# Development Management Sub Committee

**Application for Planning Permission 19/04238/FUL.  
at Kirkgate Church, 1 Kirkgate, Edinburgh.**

**The proposed works is to stabilize the ground within the church yard by taking down and rebuilding the existing structurally unsound boundary retaining wall with new engineered foundations and reinforced concrete wall.**

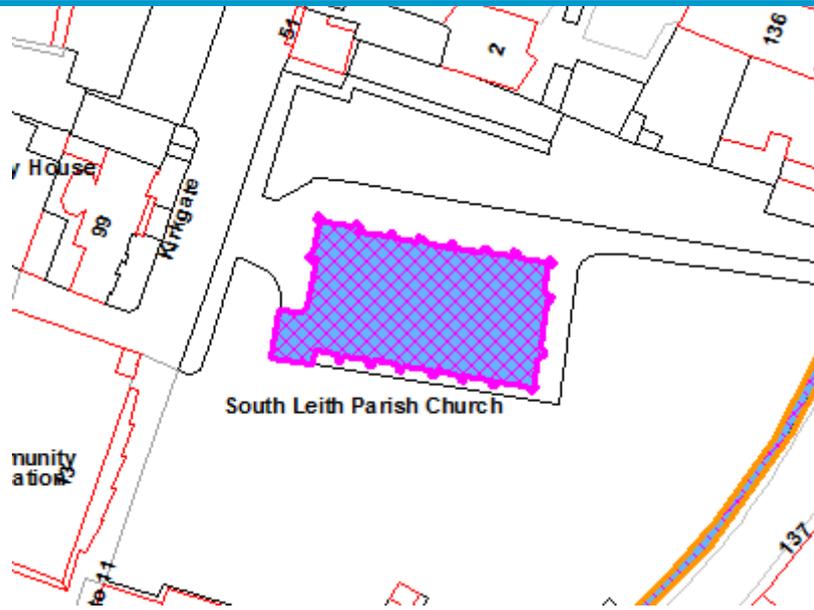
*However, regarding the new replacement wall facing Constitution Street, the current application contains far less detail, and appears to be of a lesser standard than that*

*approved in 2012. Although we have no concerns with a reinforced concrete wall, we noted at the pre-application meeting that an embossed concrete finish to the wall was not appropriate, and that the standard of the previously approved scheme (lined lime plaster finish and stone cope, string and cornice) should be emulated.*

*Although the drawings show the replacement and replication of a stone cope, there is no further information or detail on how the new wall will be constructed, including the projecting rusticated features and no stone cornices or string courses are shown. We would recommend additional details showing a lime-based render finish and stone detailing as before. This may mean some changes to the treatment of the reinforced concrete sub wall.*

*The drawings show 'new railings to match existing' but we would recommend that new cast iron railings to match the original churchyard pattern are provided, as with the 2012 application.*

*We have no concerns with the repositioning of the OLE poles on the top of the new wall. We note that the walling - with its impervious cement coating - has moved and is in danger, meaning some remedial work would likely be necessary even without the tram works.*

*To conclude, we accept, as before, the need for the wall to be rebuilt, but do not support the diminution in quality of its proposed replacement. We would suggest that additional discussion and details are provided to guarantee the quality of the new build elements.*

*There should be detailed conditions on the new railings and trial panels for render, stonework and monument repair and re-siting.*
